Z-45 2017-GIS

APPLICANT: Traton Homes, LLC

PETITION NO.: Z-45

PETITION FOR: RSL (Non-Supportive)

Z1.00

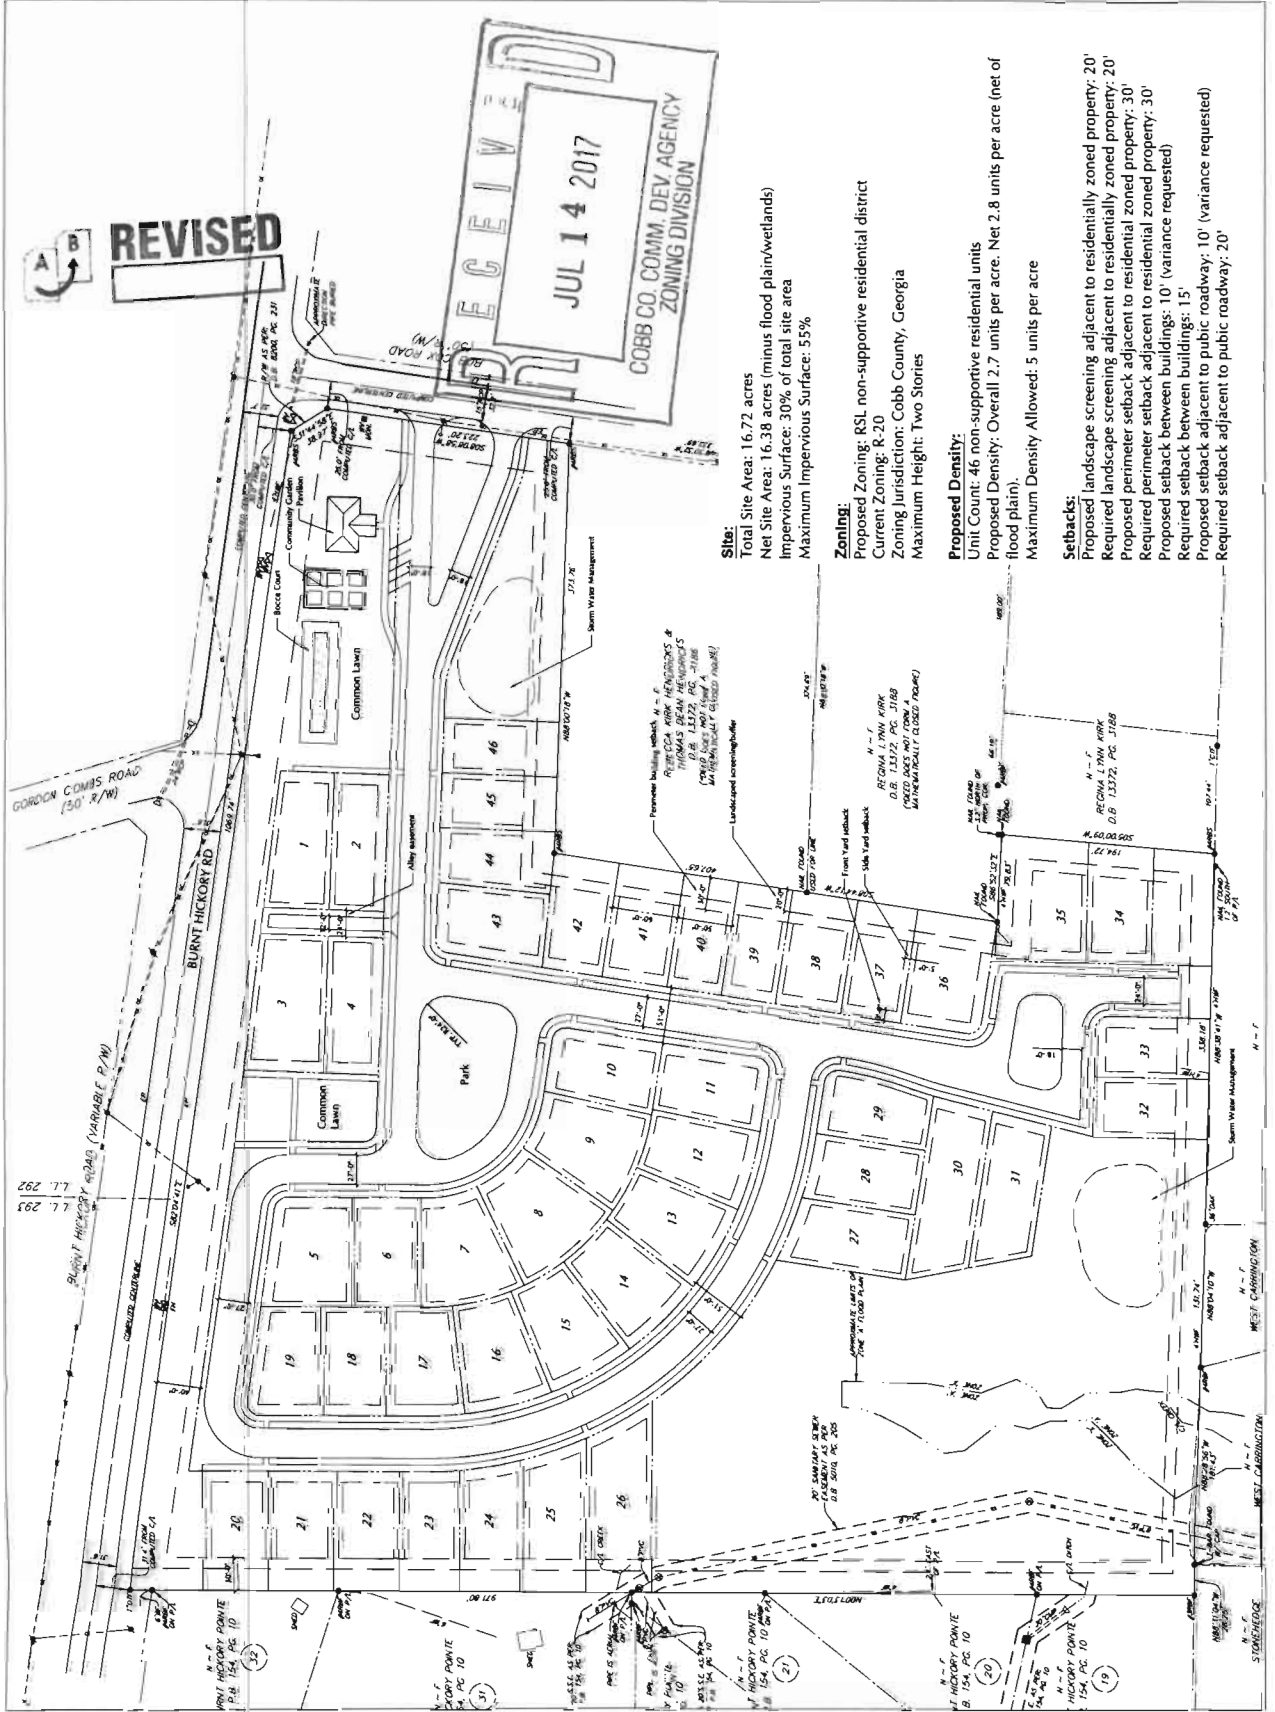
1. Reduction in the minimum setback between buildings from 15 feet to 10 feet;
2. Reduction in the minimum setback adjacent to public roadways from 20 feet to 10 feet; and
3. Reduction in the minimum perimeter building setback from 30 feet to 24 feet at one specific location as indicated on the site plan.

Moreover, the Code calls for RSL nonsupportive residential developments to be compatible with neighboring residential uses. While there is no minimum lot size required for RSL developments, the Code specifies a maximum density of five (5) units per acre (upa) which may be reduced by the Board when necessary. With a proposed 3.5 upa (net of floodplain/wetlands), the development is less than the max of five (5). However, the aforementioned variances may be indicative of an attempt of creating a development with more units than is reasonable for the site.

Certainly, the proposed 3.5 upa is more than those communities in the immediate area. To the south, West Carrington Unit II contains 36 lots at a density of 2.19 upa. Burnt Hickory Pointe to the west has 32 lots for a density of 1.71 upa, a number that is only half of the applicant’s proposal. Furthermore, Chimney Hollow Subdivision located to the north contains 10 lots at an even lower 1.2 upa. Ranging from 1.2 upa to 2.19 upa, the surrounding neighborhoods are much less dense than the applicant’s proposal of 3.5 upa.

- Provide comprehensive hydrology/stormwater controls to include development of out parcels.
- Submit all proposed site improvements to Plan Review.
- Any **spring activity** uncovered must be addressed by a qualified geotechnical engineer (PE).
- Structural fill _____ must be placed under the direction of a qualified registered Georgia geotechnical engineer (PE).
- Existing facility.
- Project must comply with the Water Quality requirements of the CWA-NPDES-NPS Permit and County Water Quality Ordinance.
- Water Quality/Quantity contributions of the existing lake/pond on site must be continued as baseline conditions into proposed project.
- Calculate and provide % impervious of project site.
- Revisit design; reduce pavement area to reduce runoff and pollution.

Recommend relocating entrance on Burnt Hickory Road further west to allow construction of a full length left turn lane at the entrance. Recommend access on Burnt Hickory Road include a deceleration lane and left turn lane. Recommend location and design be determined during plan review, subject to Cobb County DOT approval.

Recommend the proposed gate be a minimum of 50' from the right-of-way and meet Cobb County Development Standards.

1. Maximum density of 2.5 units per acre net of any floodplain/wetlands;
2. Final site plan to be approved by the District Commissioner;
3. Landscape plan to be approved by the District Commissioner;
4. Fire Department comments and recommendations;
5. Sewer and Water Division comments and recommendations;
6. Stormwater Management Division comments and recommendations;
7. Department of Transportation comments and recommendations; and
8. Owner/developer to enter into a Development Agreement pursuant to O.C.G.A. §36-71-13 for dedication of system improvements to mitigate traffic concerns.
